Access Compliance Report

Public Rights-of-Way

(Pedestrian Signals)

Intersection ID: N/A	Main Street:	Cross Street: N/A	Location: N/A
ADA ID: F56172F165F9	Signal Type: Two Push Buttons-Non APS	Overall Compliance: No	Severity Score: BTN 1:N/A BTN 2: N/A No BTN: N/A
Codes/Mitigation Info/Possible Solution		Field Measurements/Component Compliance

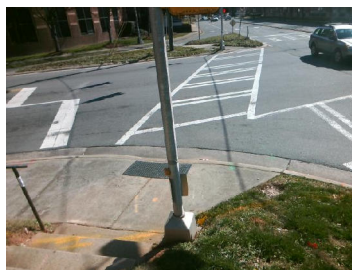
Surveyor Notes: B2 BUTTON IS IN FRONT OF STEPS

PROW/ADA: TMUTCD 4e.08, R404.2, R406.2

Possible Solutions: Replace Signal Push Button With APS Button on New Post. Remove & Relocate Sign.
